CITY OF TAMPA

ADDENDUM NO. 2

DATE: October 11, 2013

Contract 13-C-00019; Howard F. Curren AWTP Screen and Grit Building No. 1 Bar Screen Replacement

SCREEN & GRIT BLDG. NO. 1.
PROPOSED PLAN
SCALE: 1/8" = 1'-0"

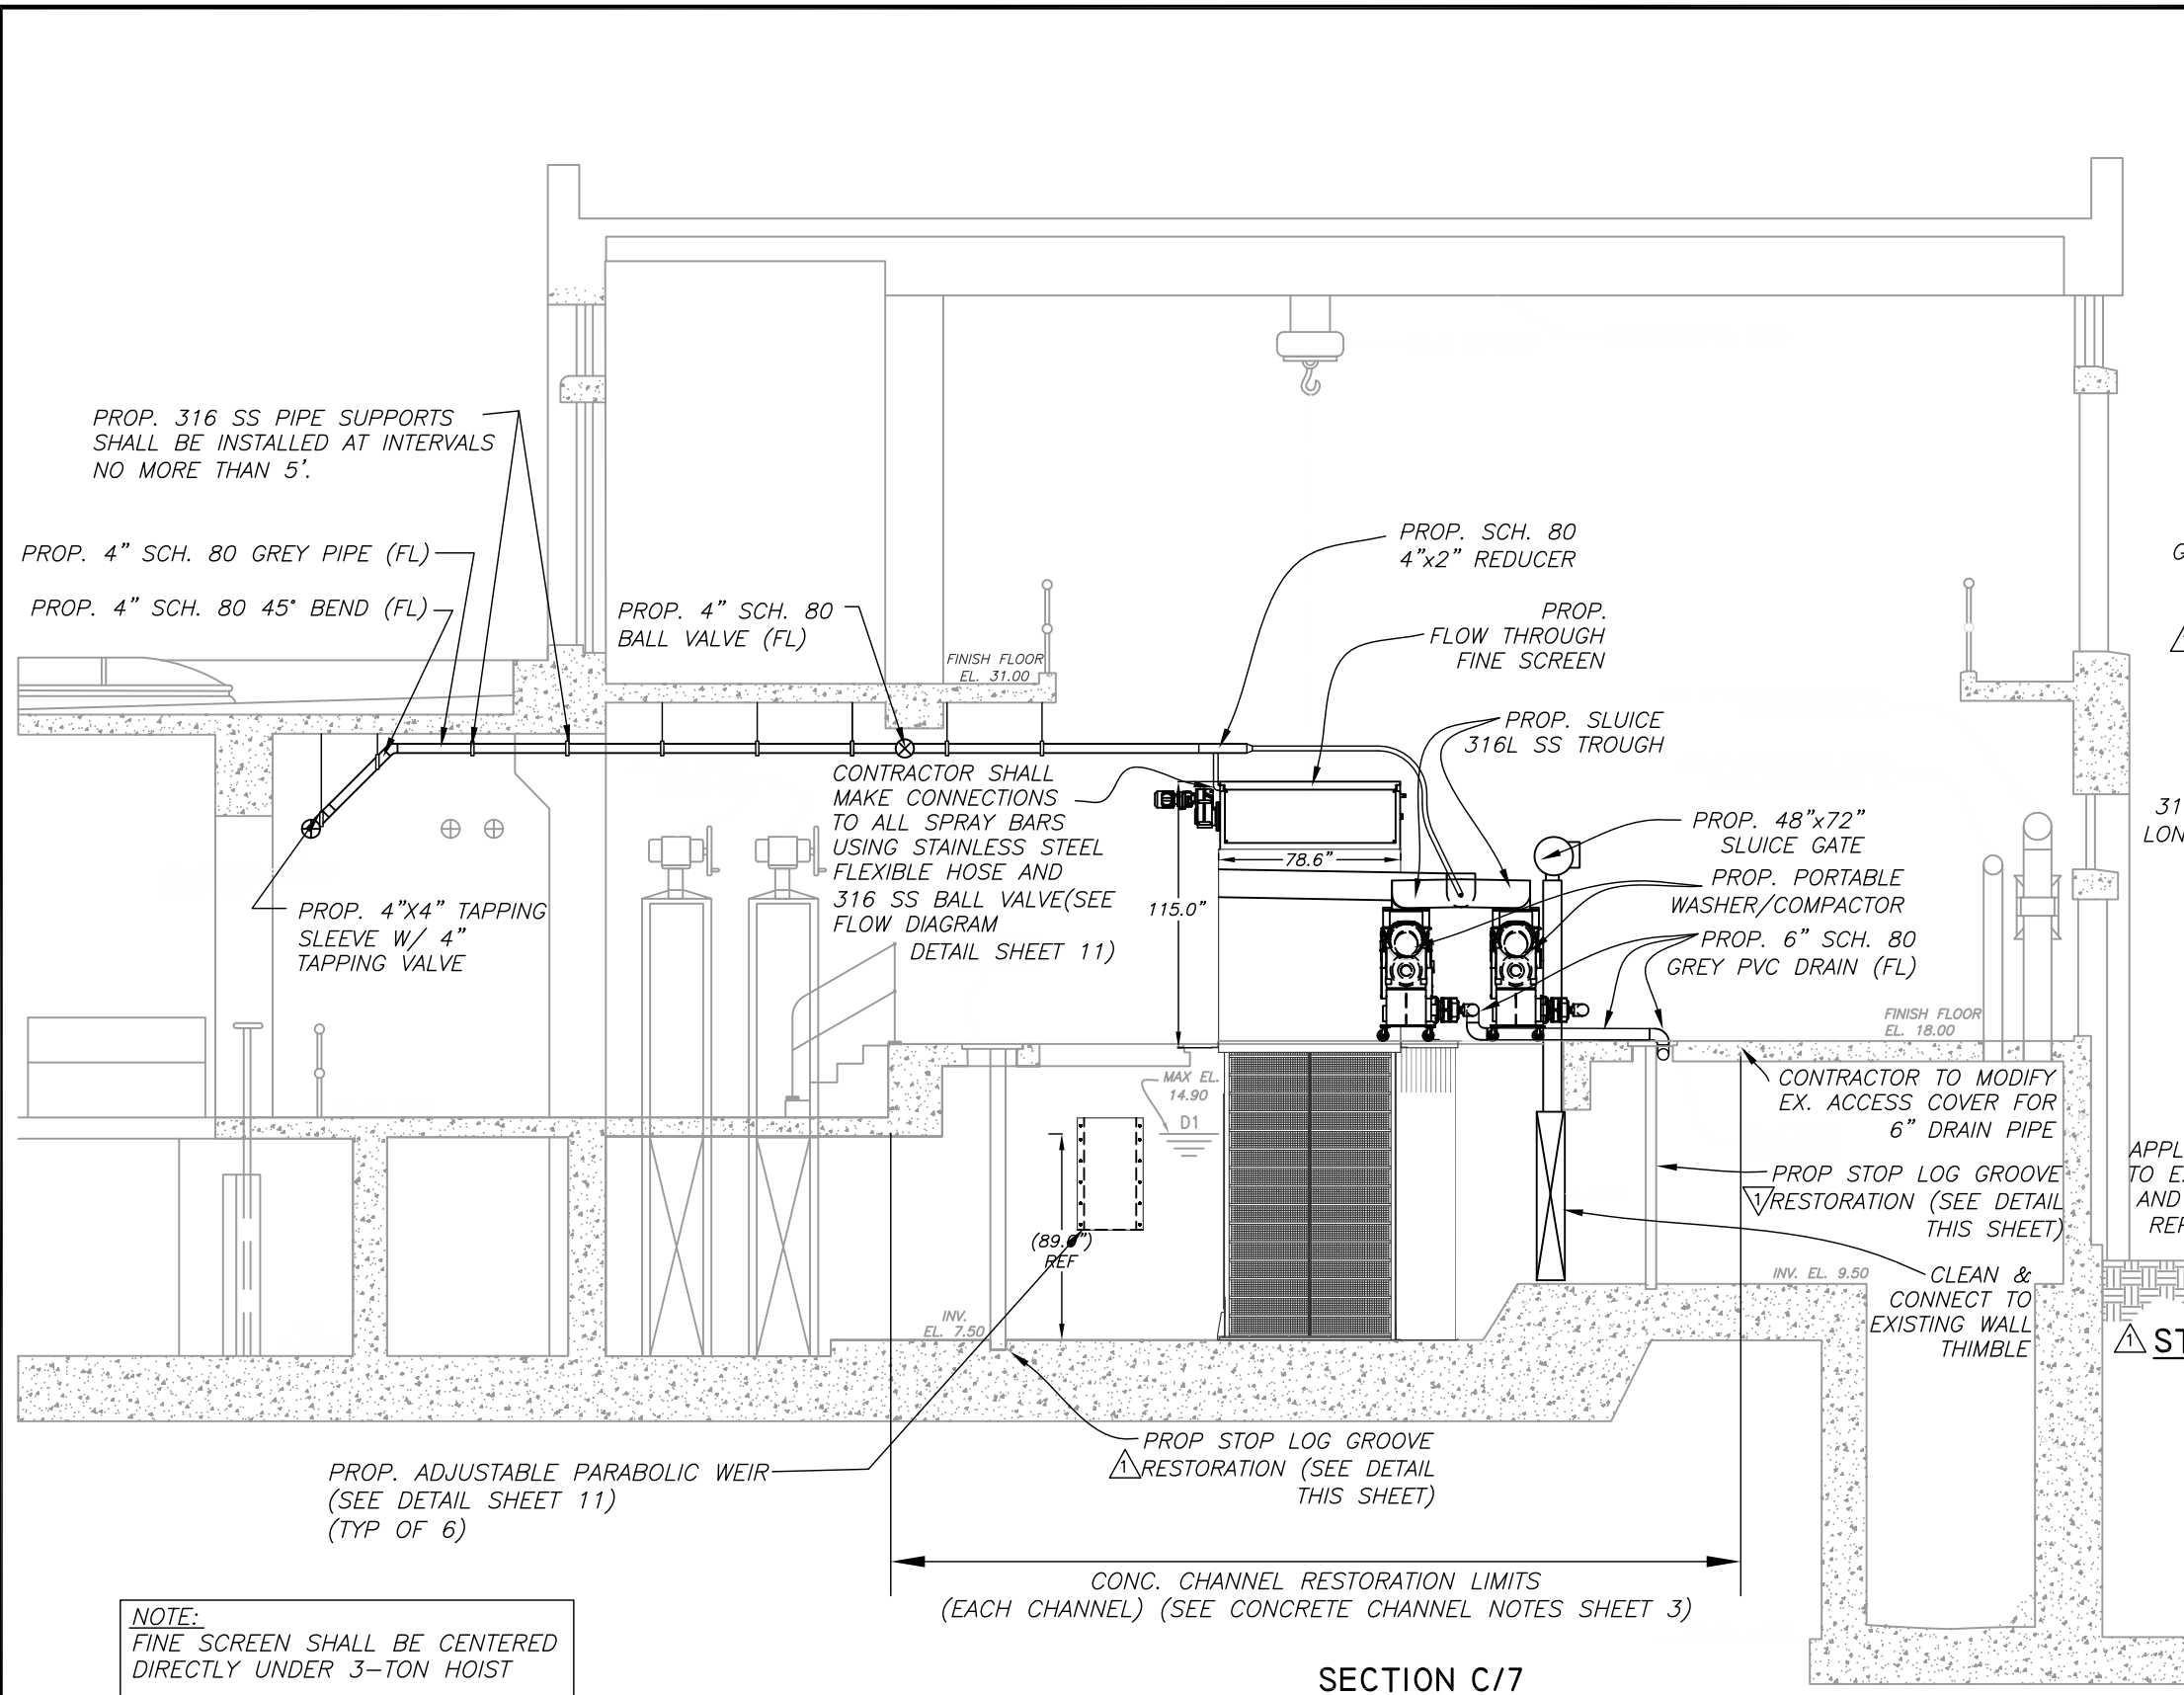
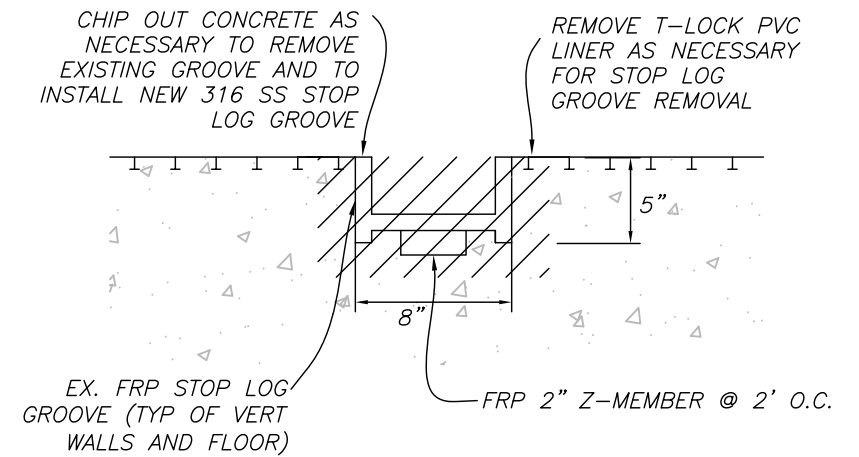
No.	DATE	REVISIONS
3		
2		
1	10-4-13	ADDENDUM #2, ADDED STOP LOG GROOVE RESTORATION AND CORRECTED SCREEN/WEIR PLACEMENT.

SECTION C/7
SCALE: 1/8" = 1'-0"

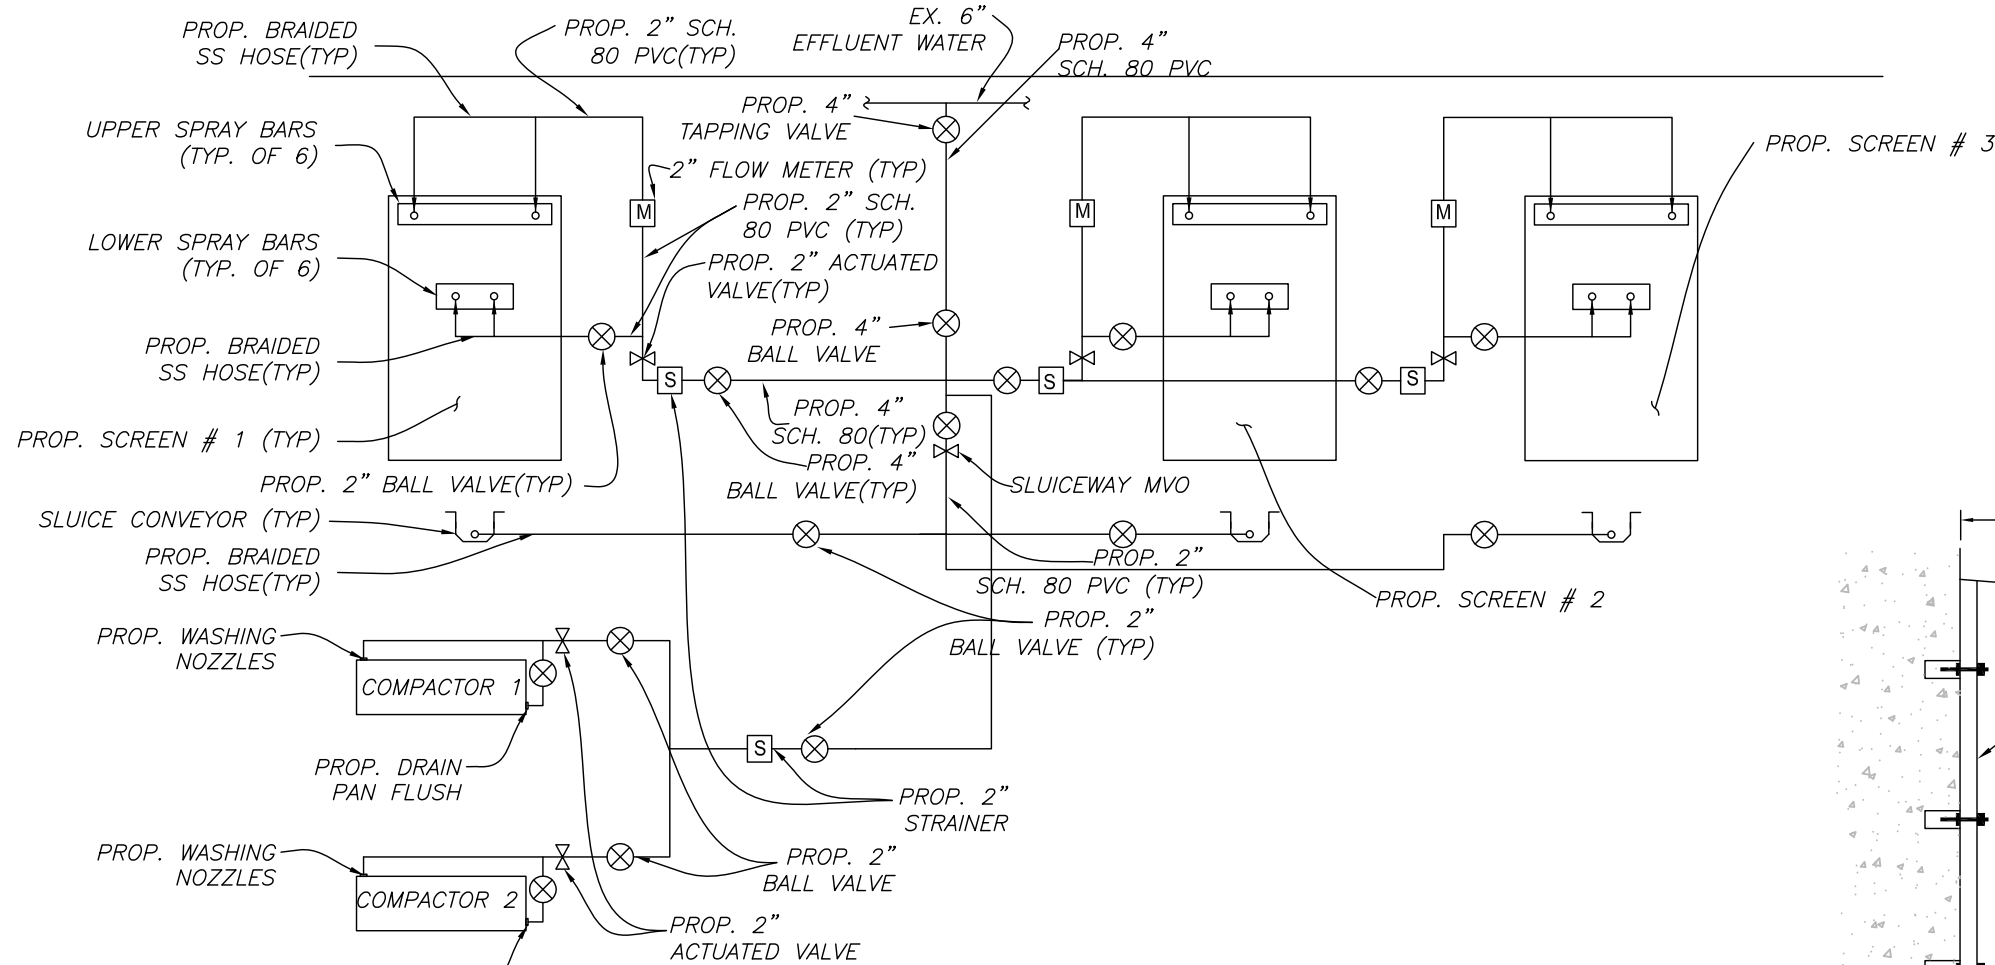
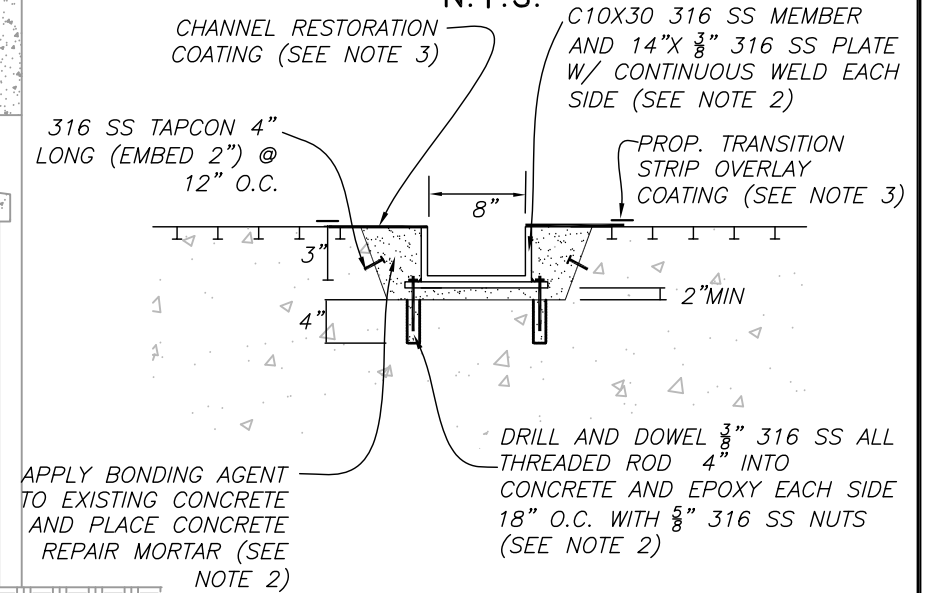
- NOTES:
1. THERE ARE A TOTAL OF 6 STOP LOG GROOVES TO BE RESTORED. THE RESTORATION INCLUDES THE WALLS AND FLOOR
 2. COST FOR THE STOP LOG GROOVE RESTORATION INCLUDING REPAIR MORTAR, SHALL BE INCLUDED IN THE PROJECT'S LUMP SUM BID ITEM
 3. PAYMENT FOR CHANNEL RESTORATION AND STRIP OVERLAY COATINGS WILL BE BASED ON APPROPRIATE UNIT COST
 4. THE FLOOR IS NOT T-LOCK LINED AND DO NOT REQUIRE COATINGS

No.	DATE	REVISIONS
3		
2		
1	10-4-13	ADDENDUM #2, ADDED STOP LOG GROOVE RESTORATION AND DETAILS

HFCWTP SCREEN AND GRIT
BLDG. No. 1 BAR SCREEN REPLACEMENT
DETAILS

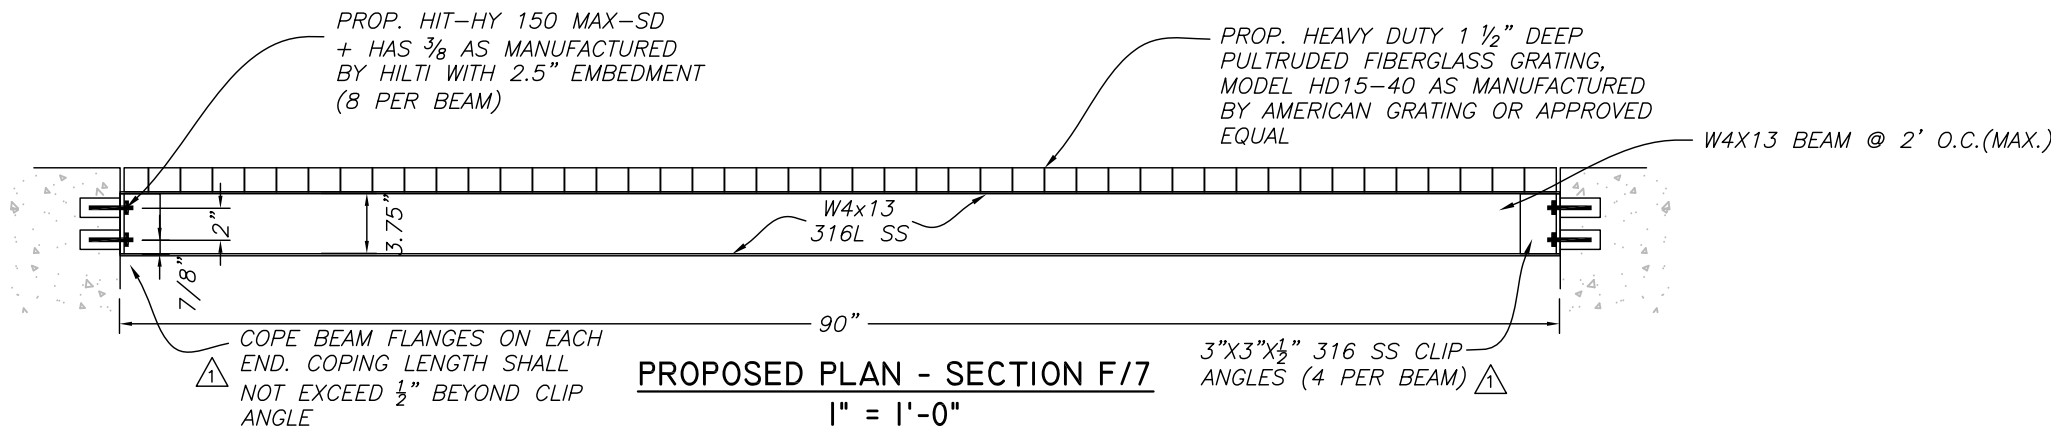
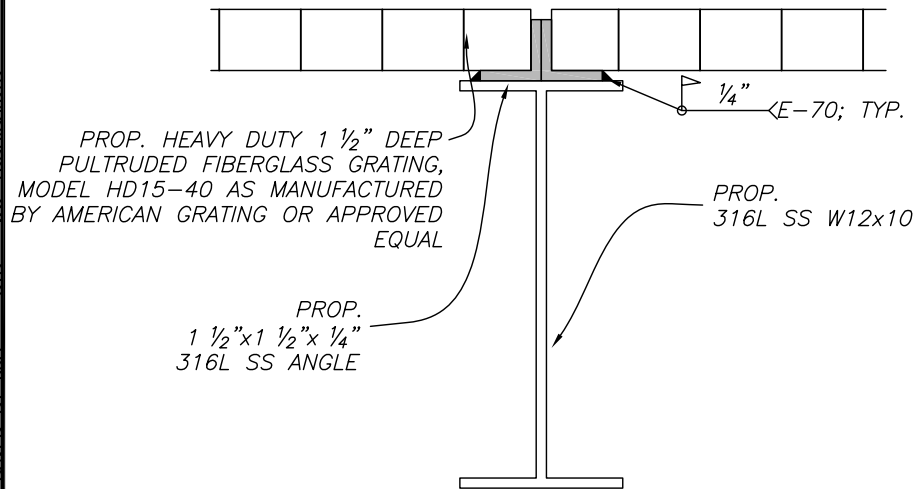
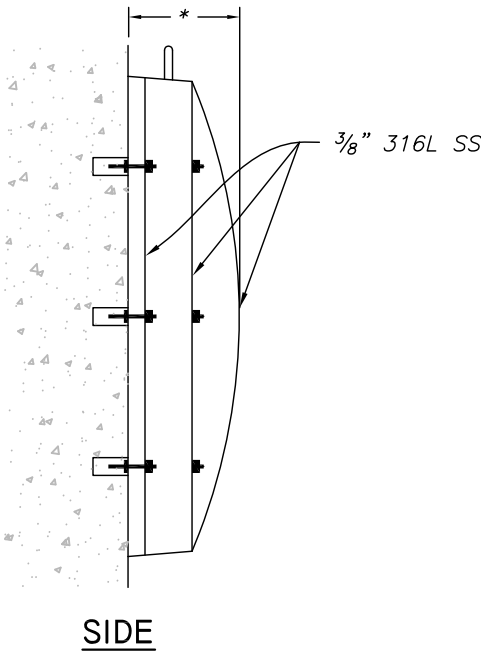
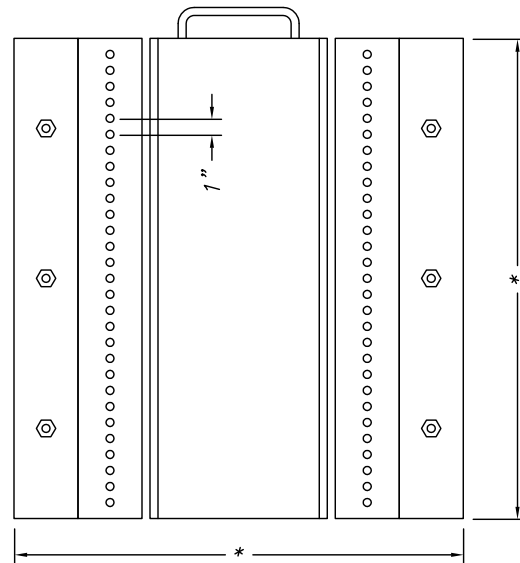
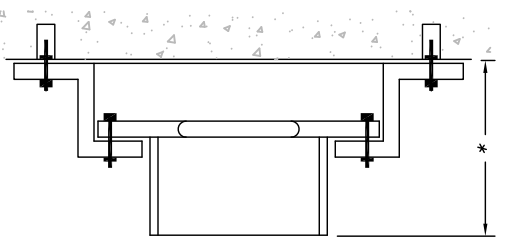
No.	DATE	REVISIONS
3		
2		
1	10-4-13	ADDENDUM #2, COPE BEAM AND SPECIFIED CLIP ANGLES
